SUBJECT: CERTIFICATION OF THE MINUTES OF THE ACRS FUTURE PLANT  
DESIGNS SUBCOMMITTEE MEETING ON THE TECHNOLOGY NEUTRAL  
LICENSING FRAMEWORK (WORKING DRAFT NUREG-1860) MARCH 7,  
2007, ROCKVILLE, MARYLAND

SUBJECT: CERTIFICATION OF THE MINUTES OF THE ACRS FUTURE PLANT  
DESIGNS SUBCOMMITTEE MEETING ON THE TECHNOLOGY NEUTRAL  
LICENSING FRAMEWORK (WORKING DRAFT NUREG-1860) MARCH 7,  
2007, ROCKVILLE, MARYLAND

ADVISORY COMMITTEE ON REACTOR SAFEGUARDS  
FUTURE PLANT DESIGNS SUBCOMMITTEE MEETING MINUTES  
MARCH 7, 2007  
ROCKVILLE, MARYLAND

Figure 6-3 Frequency-consequence curve.

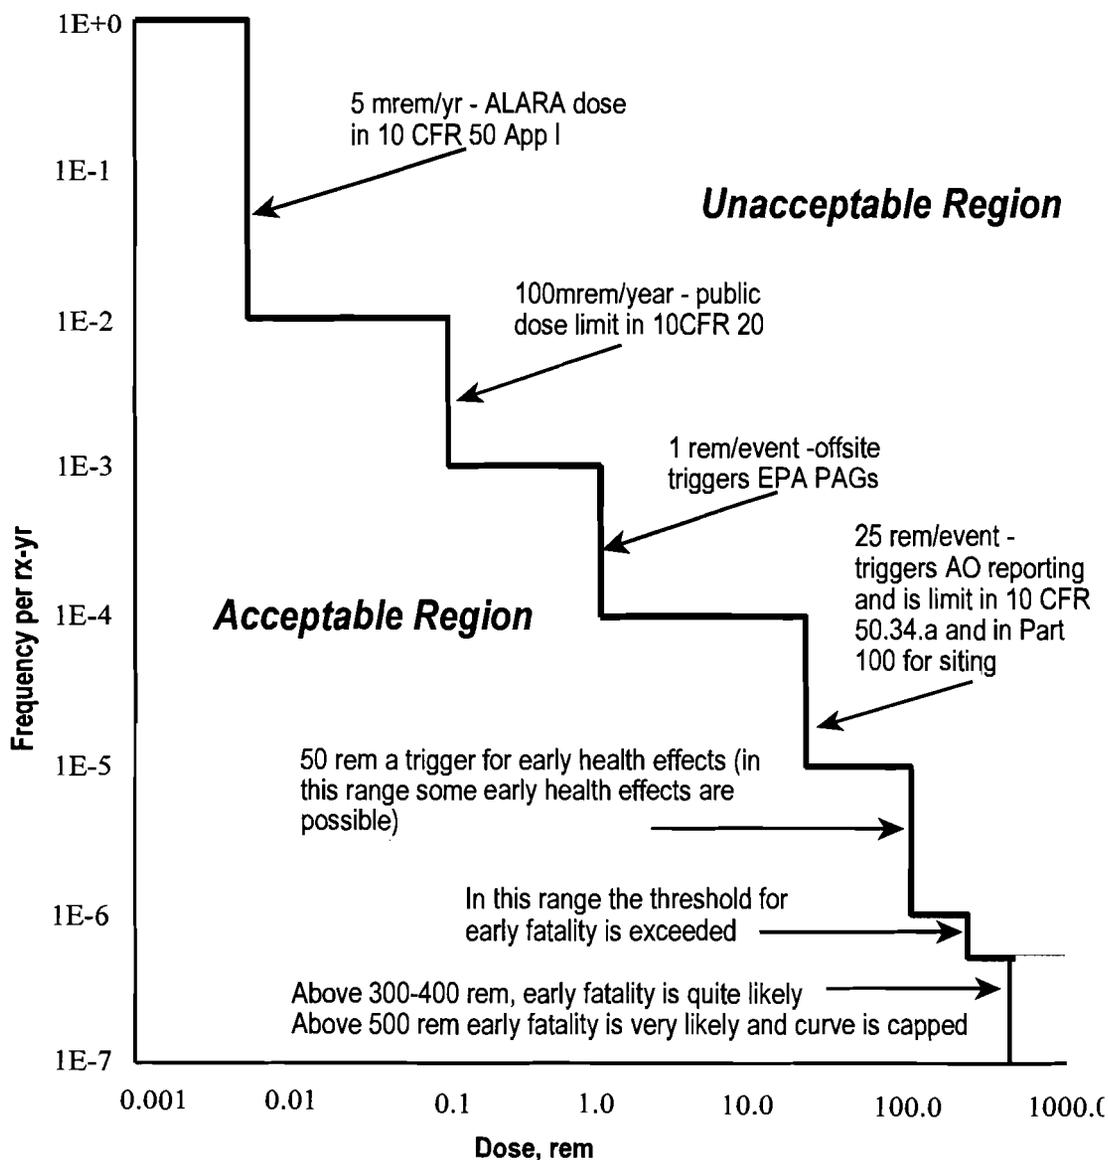
The subcommittee spent a considerable amount of time discussing the frequency-consequence (F-C) curve contained in draft NUREG-1860 (i.e., Figure 6-3).

- Different anchor points
- Add a CCDF curve

Dr. Kress questioned why the proposed F-C curve was not replaced with a straight line. With a slope of approximately negative one, the curve shows a risk-aversion towards the end of the curve. The subcommittee and staff discussed the use of a CCDF F-C curve versus use of the QHOs. Dr. Kress expressed concern over using the QHOs because he said they are site-related characteristic. He also said that a plant can be designed to meet the QHOs, but then questioned how one would address a multiple-unit site. Dr. Kress suggested using a CCDF F-C curve, equivalent to a CDF of  $10^{-5}$  and LERF of  $10^{-6}$ , as a design requirement for fission product release. He added that then you could put 10 plants on a site and still meet the QHOs. Dr. Apostolakis expressed concern over making the design curve overly conservative. He favored having separate siting requirements (expanded QHOs that perhaps address societal things). Dr. Apostolakis said that for the Committee to make an informed decision on the framework it needs to know, in detail, what other organizations have proposed and how they differ with the staff. The subcommittee discussed the need for writing a Committee letter on the framework (i.e., to respond to the November 8, 2006 SRM, to provide the staff with its comments on technical/policy aspects of the framework). Ms. Drouin said that public comments on the framework were generally favorable, at the conceptual level, but most indicated that they wanted to see it tested before the staff proceeded with rulemaking. She said that the staff did a very limited test of the framework on an existing LWR and that the July version of the framework reflects that test. She said that a more complete test of how the framework translates into actual requirements will be published in the version of the framework they plan on issuing early this summer. The version to be published early this summer would also contain an appendix that summarized all the stakeholder comments. The subcommittee discussed the possibility of testing the framework on an actual plant (e.g., PBMR, NGNP). Mr. Ruben, part of an inter-office team looking at the licensing strategy for the NGNP, described several licensing approaches being considered by the staff, each with varying degrees of the use of PRA information. The spectrum of options includes 1) using a completely deterministic

Figure 6-3 Frequency-consequence curve.

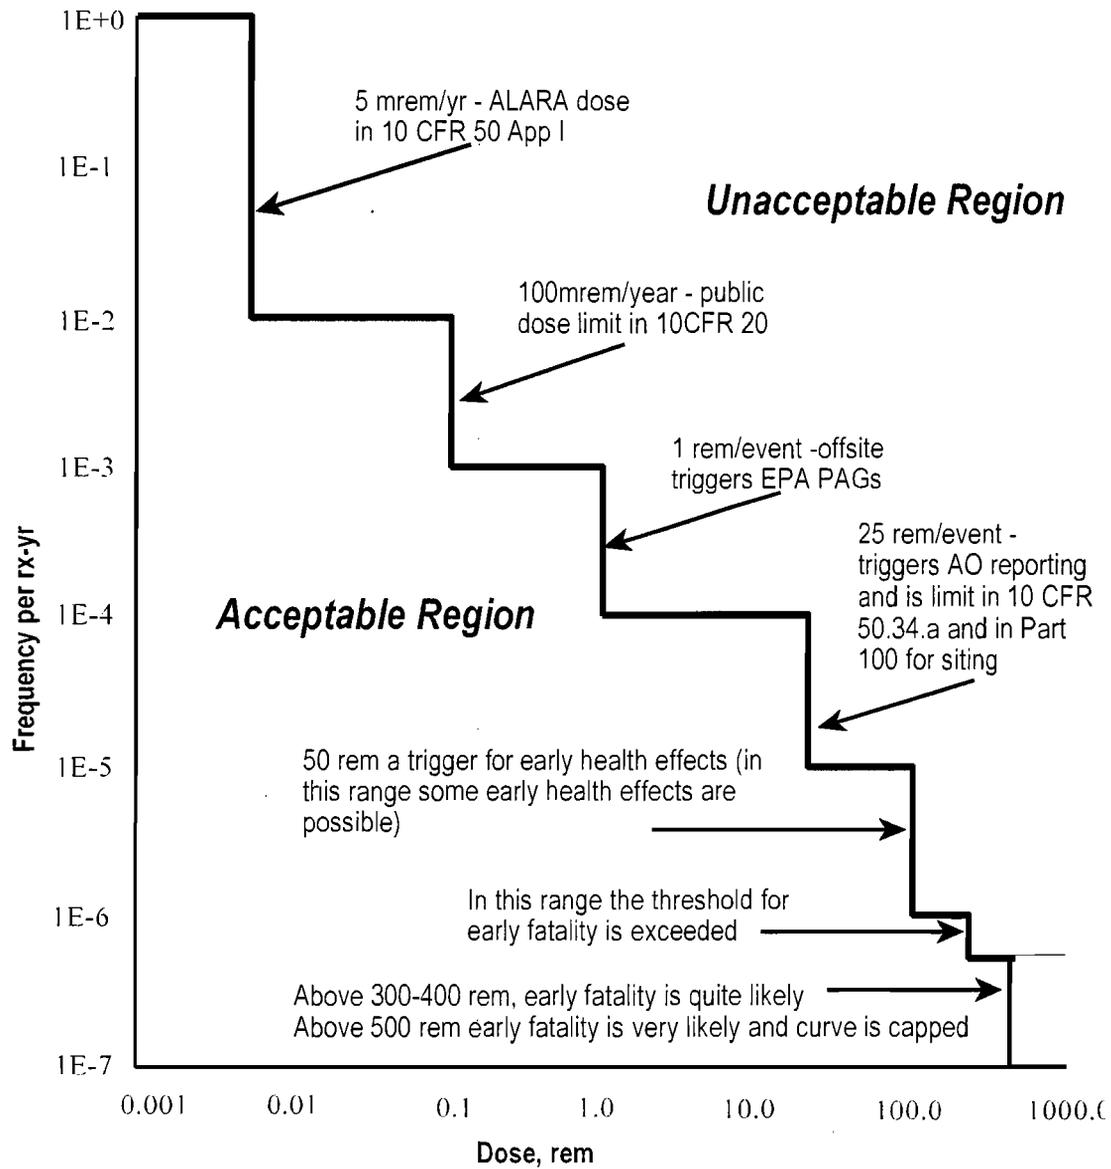
The subcommittee spent a considerable amount of time discussing the frequency-consequence (F-C) curve contained in draft NUREG-1860 (i.e., Figure 6-3).

- Different anchor points
- Add a CCDF curve

Dr. Kress questioned why the proposed F-C curve was not replaced with a straight line. With a slope of approximately negative one, the curve shows a risk-aversion towards the end of the curve. The subcommittee and staff discussed the use of a CCDF F-C curve versus use of the QHOs. Dr. Kress expressed concern over using the QHOs because he said they are site-related characteristic. He also said that a plant can be designed to meet the QHOs, but then questioned how one would address a multiple-unit site. Dr. Kress suggested using a CCDF F-C curve, equivalent to a CDF of  $10^{-5}$  and LERF of  $10^{-6}$ , as a design requirement for fission product release. He added that then you could put 10 plants on a site and still meet the QHOs. Dr. Apostolakis expressed concern over making the design curve overly conservative. He favored having separate siting requirements (expanded QHOs that perhaps address societal things). Dr. Apostolakis said that for the Committee to make an informed decision on the framework it needs to know, in detail, what other organizations have proposed and how they differ with the staff. The subcommittee discussed the need for writing a Committee letter on the framework (i.e., to respond to the November 8, 2006 SRM, to provide the staff with its comments on technical/policy aspects of the framework). Ms. Drouin said that public comments on the framework were generally favorable, at the conceptual level, but most indicated that they wanted to see it tested before the staff proceeded with rulemaking. She said that the staff did a very limited test of the framework on an existing LWR and that the July version of the framework reflects that test. She said that a more complete test of how the framework translates into actual requirements will be published in the version of the framework they plan on issuing early this summer. The version to be published early this summer would also contain an appendix that summarized all the stakeholder comments. The subcommittee discussed the possibility of testing the framework on an actual plant (e.g., PBMR, NGNP). Mr. Ruben, part of an inter-office team looking at the licensing strategy for the NGNP, described several licensing approaches being considered by the staff, each with varying degrees of the use of PRA information. The spectrum of options includes 1) using a completely deterministic

Figure 6-3 Frequency -consequence curve

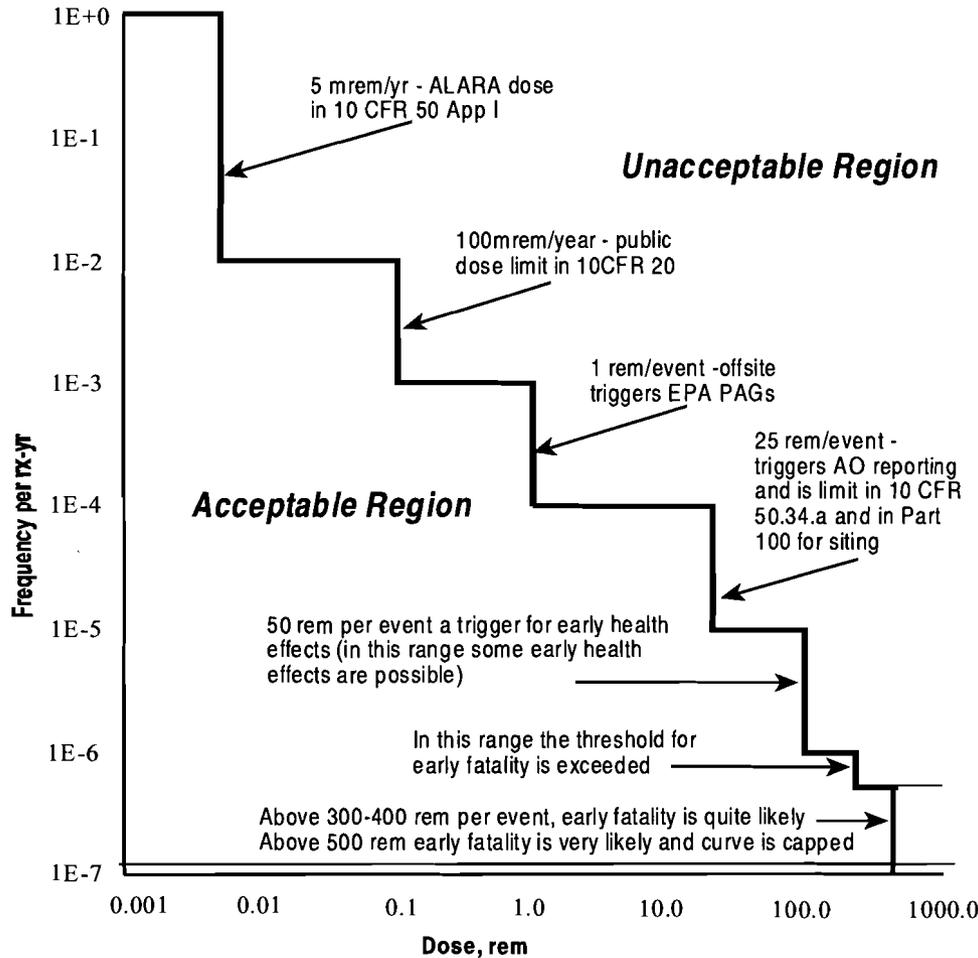
Stakeholder comments:

- Different anchor points
- Add a CCDF curve
